SERVICE BULLETIN

SB-080323-A

“I hereby certify the inspection and/or repair has been completed in accordance with Service Bulletin (SB-080323-A, Nose Gear Collapse) and all referenced documents. Potentially unclear procedures have been clarified with ICON Aircraft. (ref. FAA Exemption 10829C)”.

Figure 1. NLG Connector D9024J, Wedge Lock (orange)

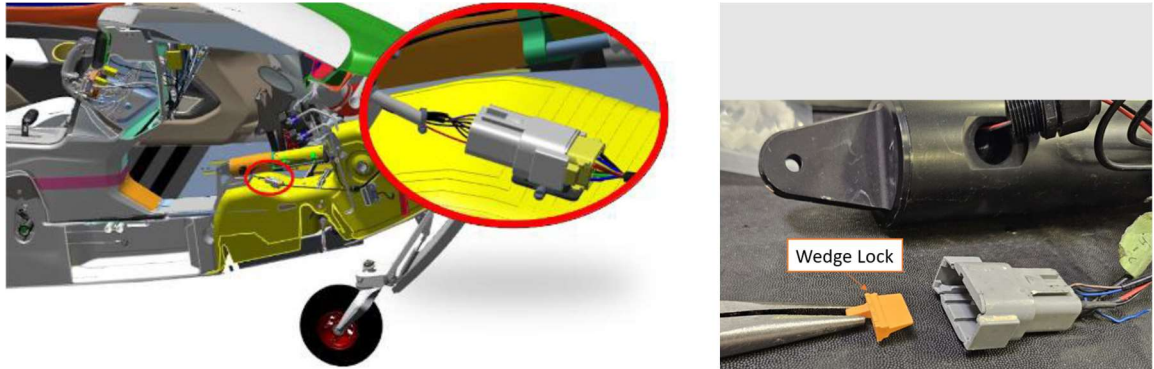
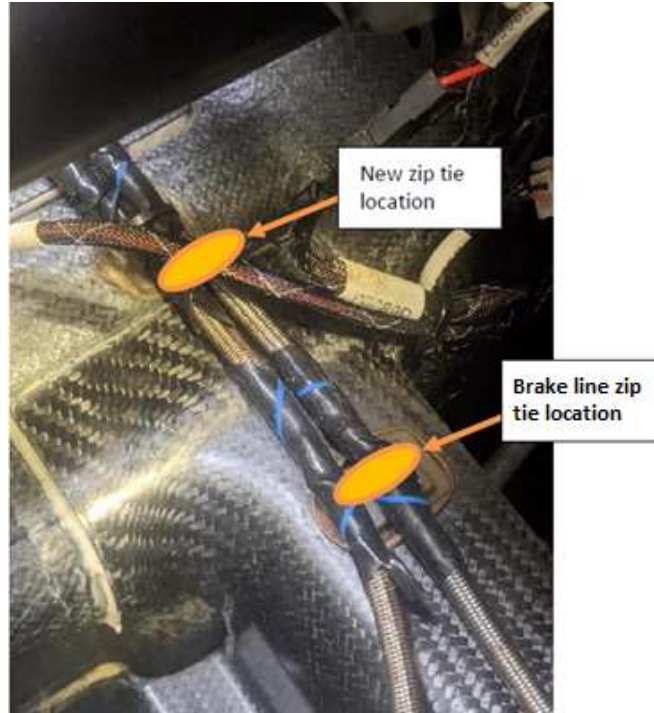
1. If replacing actuator, disconnect bolts, worm drive hose clamp, and boot in accordance with Aircraft Maintenance Manual section 100425. Cut zip tie around NLG connector and disconnect the NLG connector D9024J. (Reference **Figure 1.**) Skip to Repair step 7.
2. Remove the instrument panel top(s) (See Aircraft Maintenance Manual, Section 100514 or 100547/100397).
3. Modify the NLG actuator harness as follows:
 - a. Cut zip tie around NLG connector and disconnect the NLG connector D9024J. (Reference **Figure 1.**)
 - b. Remove Wedge lock from actuator-side connector body. (Reference **Figure 1.**)

Figure 2. Trim wires at reed switches

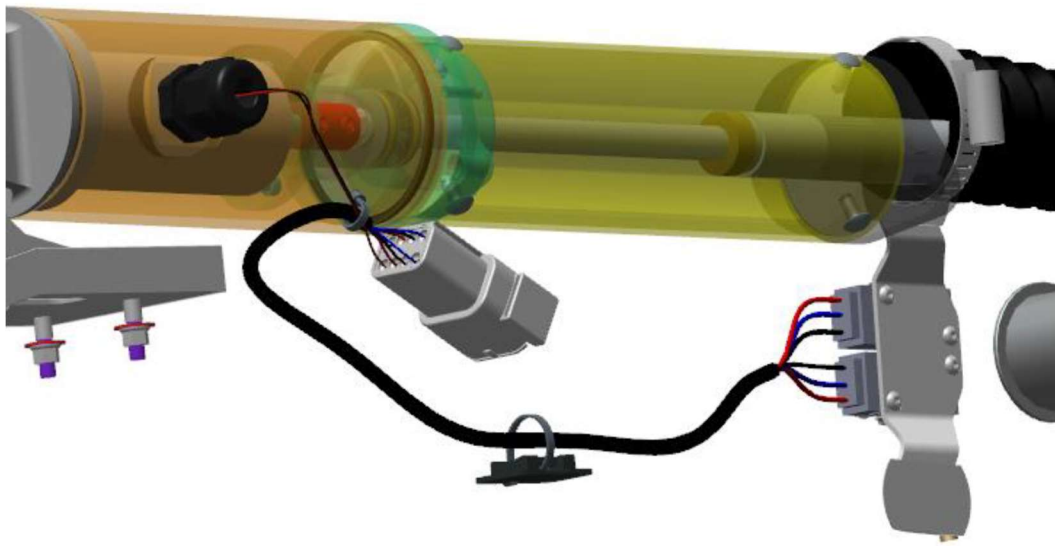
- c. Mark wires pinned to connector positions 1 and 8 with masking tape. Remove all electrical connector pins/wires in the existing NLG connector PN D9024J, (located on the actuator side).
- d. Remove sleeving from the actuator wire bundle and pull the wires out of the bundle that leads to the magnetic reed switches located on the connector body. Note: The reed switch wires are encased in larger black insulation. Trim the reed switch wires where they exit the reed switches as shown in **Figure 2**. Discard these trimmed wires. Note: the wires that were located in connector positions 1 and 8, the red and black wires that enter the actuator body and were marked in step c, must not be trimmed or altered in any way.

Figure 5. Limit switch bracket sub assembly

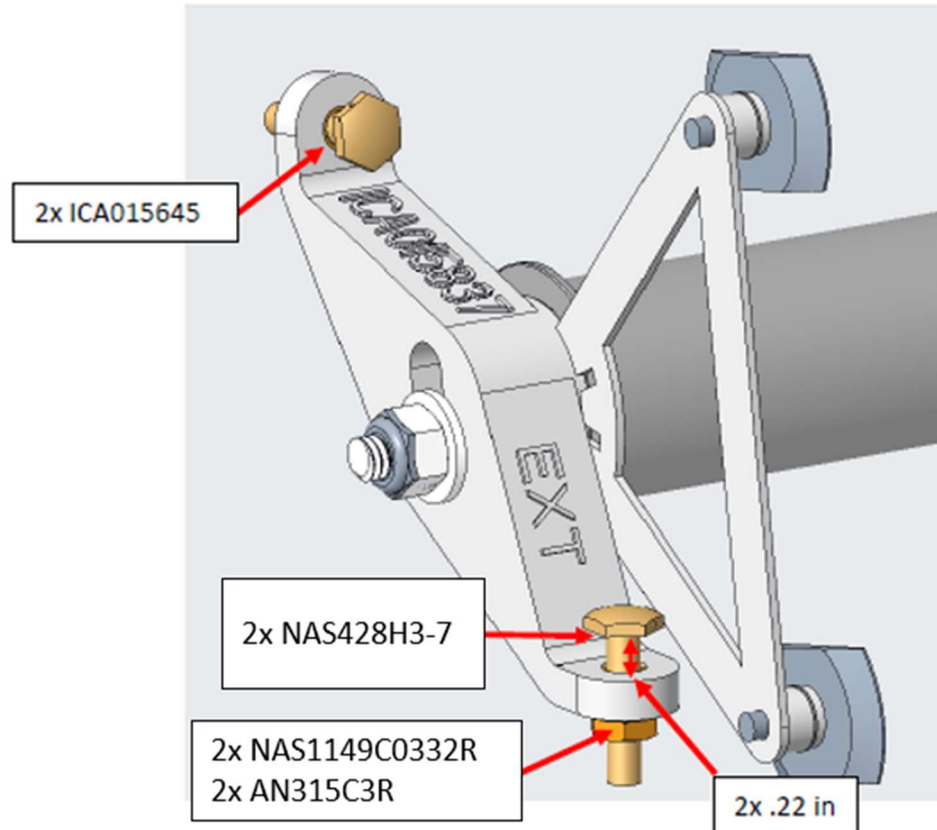
- Install 2 each bolt (NAS428H3-7), 2 each washer (NAS1149C0332R) and 2 each nut (AN315C3R) as shown in **Figure 5** onto 1 each the new retrofit NLG Limit Switch Bracket assembly. Set pre-gap (.22 in) as specified below. Pre-install jam nut (AN315C3R) finger tight but do not torque.

Figure 6. NLG Bell crack Shaft bolt

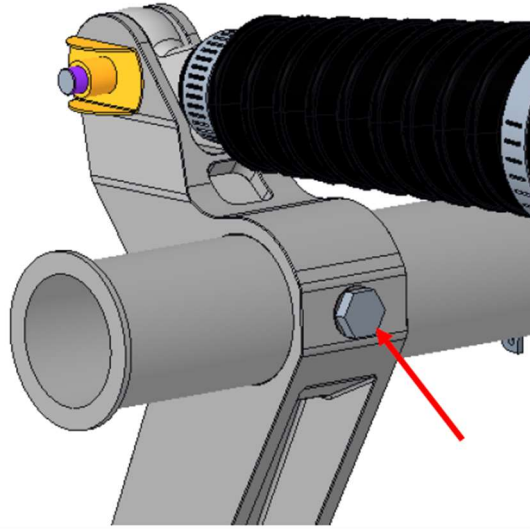
- Preinstall the new retrofit Limit Switch Bracket sub-assembly into the bell crank shaft. Orient the assembly so it slides over the bell crank shaft bolt shown in **Figure 6**.
- If needed, identify any areas of interference between the Limit Switch Bracket and ECS heater bracket by pre-installing 1 each of the CLICKBOND studs (CB4000G08CRA8P750) approximately as shown in **Figure 7**. Mark the area of interference with ECS heater bracket with a permanent black marker. Loosen from each CLICKBOND stud, shim the gap and cut away interference area with a hand cutting tool. Be careful not to damage the surrounding area. Clean working area to remove all FOD, including carbon dust, with a shop vac.

10. Insert ICA015837 Limit Switch Retrofit Bracket into the bell crank shaft, orient it so it slides over the bell crank shaft bolt shown in **Figure 6** above. Remove zip-tie from hold down bolt assembly, remove and retain the washer and nut. Insert hold down bolt from co-pilot side of NLG box, and secure with 1 each retained washer and 1 each locking nut (95615A120) on the pilot side of the NLG Box. Torque to 17±2 in-lbs. (Reference **Figure 9**)

Figure 8. NLG limit switch bracket assembly installed; (1.0 configuration: orient as shown on right)

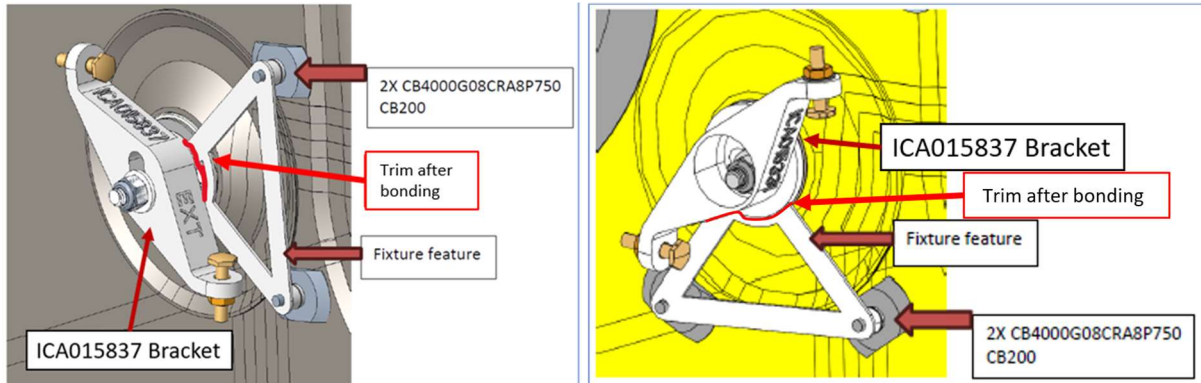
13. With rig pin still installed, or using ITL001714-B if no rig pin hole is available, bond CLICKBOND studs (CB4000G08CRA8P750) in the place oriented by the fixture (Reference **Figure 8**). Bond using CB200 in accordance with manufacturer recommendations. Backfill as needed with CB200 where stud overhangs core.
14. After allowing to adequately cure, use a razor knife to carefully trim away the fixture close to the base as shown in red line in **Figure 8**.
15. (1.0 config only) Install edging (MS21266-1N Grommet Edging)) with CB200 at location shown in **Figure 10** and route harness as shown.

Figure 11. Installed limit switch subassembly; (1.0 config: Orient as shown on right)

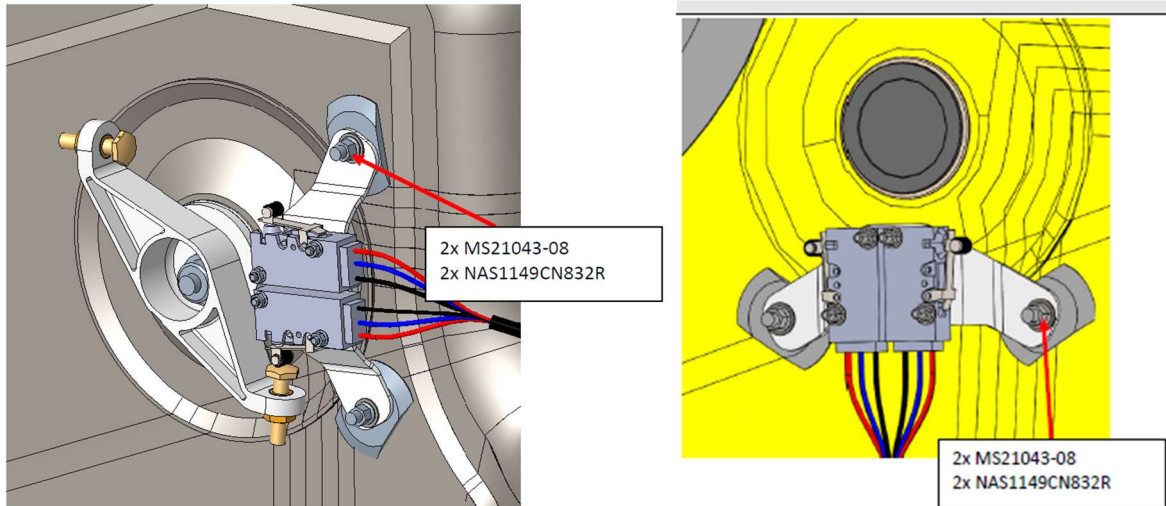
16. Install limit switch assembly onto studs with 2x MS21043-08 nuts and 2x NAS1149CN832R washers as shown in **Figure 11** below. Torque locknuts to 14 in-lbs.

Figure 12. Adjust bolt gap

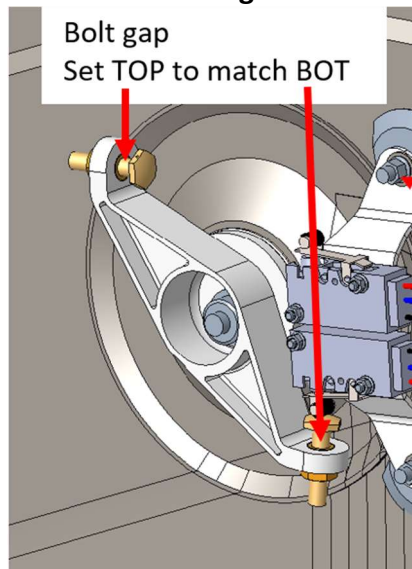
17. If the actuator was previously disconnected or replaced, loosen the clamp securing the NLG boot to the shaft of the actuator. Manually rotate the shaft of the actuator (clockwise to retract, when viewed from the front) for best rig pin or ITL001714 tool alignment. Reconnect the actuator and tighten the boot clamp (See Aircraft Maintenance Manual Section 100359-00).
18. Adjust bolt on limit switch retrofit bracket so bottom (“BOT”) extended limit switch is activated. Adjust bolt gap on limit switch retrofit bracket so that top (“TOP”) side has the same gap as the bottom. Torque jam nut to 15±2 in-lbs. Reference **Figure 12**.

Figure 13. Rigging with gear up

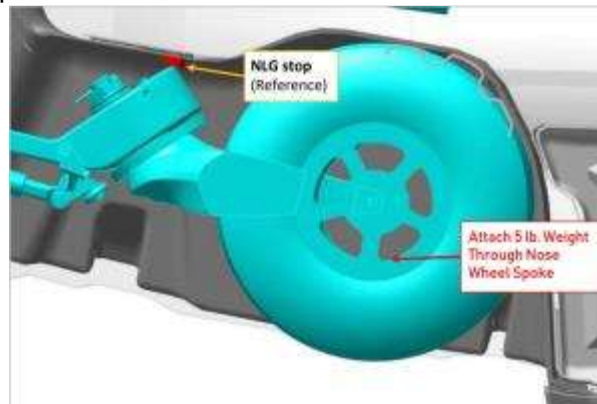
- c. Confirm that 15A MLG fuse is removed. Verify MASTER switch is OFF and the landing gear is currently DOWN. Move LANDING GEAR switch to UP position then turn MASTER switch ON to allow the landing gear to retract fully. Turn MASTER switch OFF.
- d. When in the UP position a single sheet of paper should slide with minimal drag between the NLG strut and stop.

- e. Adjust rigging by loosening jam nut and adjusting crowned bolt for TOP bolt (NAS428H3-7) (**Figure**). Re-torque jam nut to 15±2 in-lbs.
- f. Verify MASTER switch is OFF and the landing gear is UP. Move LANDING GEAR switch to DOWN position then turn MASTER switch ON to allow the landing gear to extend fully. Turn MASTER switch OFF.
- g. Remove 5lb weight (ITL012297) from NLG wheel.
- h. Install rod into NLG strut: Using isopropyl alcohol, clean surfaces where lubricant will be applied. Apply lubricant (ICA012078) liberally to threads and shank of bolt. Install rod into NLG strut with bolt and washer. Torque bolt to 25-28 in-lb. (Reference **Figure 14**)

Figure 14. NLG Strut Hardware

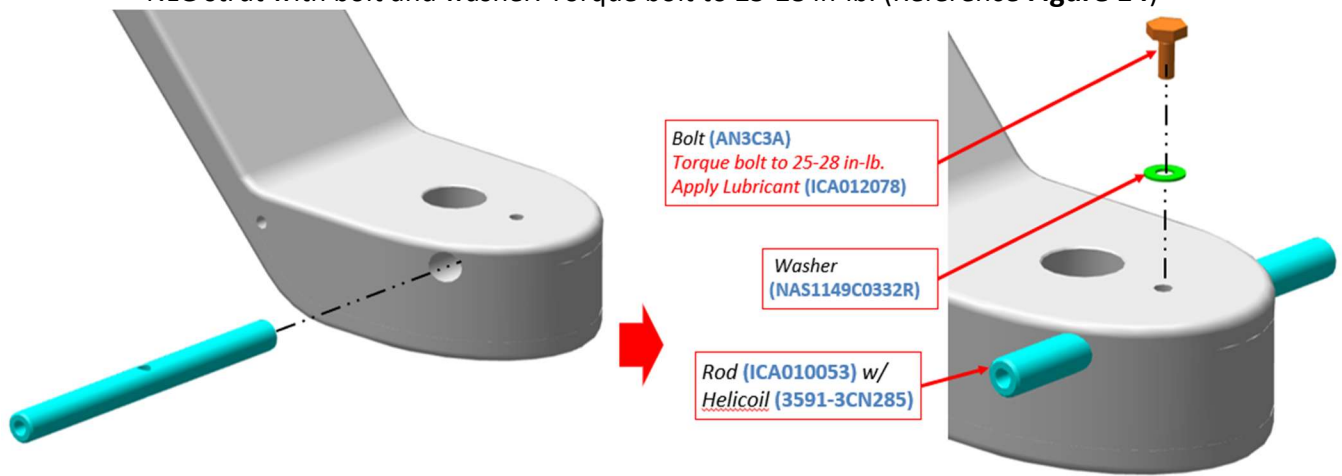
19. Rig NLG system with gear UP.
 - a. Remove the bolt, washer, and rod which engage the doors from the NLG strut. (**Figure 14**)
 - b. Attach 5lb weight (ITL012297) to NLG wheel.

Figure 15. NLG retrofit Tie mount block

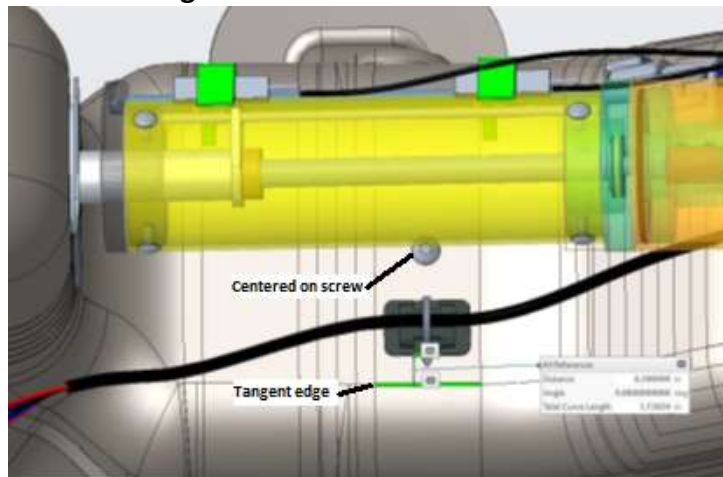
4. (1.0 config only) Remove zip- tie securing the wiring harness to the brake line (**Figure 3**.)
NOTE: If additional slack for harness is needed, it is permissible to also relocate the zip- tie shown in **Figure 15**.

- a. Nose gear doors close fully against the fuselage skins with no gaps or looseness.
 - b. There are uniform gaps between the edges of the doors and the fuselage joggle.
 - c. The door flanges rest against each other.
 - d. Instrument panel position lights indicate correctly.
 - e. Normal gear function with no blown fuses.
 - f. .1625 rig pin (ITL002663) (or ITL001714 for 1.0 config) fits.
 - g. If adjustment of the extended position is necessary, adjust rigging by loosening jam nut and adjusting crowned bolts (NAS428H3-7). Re-torque jam nut to 15±2 in-lbs.
21. Install tie mount on the NLG box. Center the mount with screw and about 0.400 inch upwards from tangent edge as shown in **Figure 15** below.
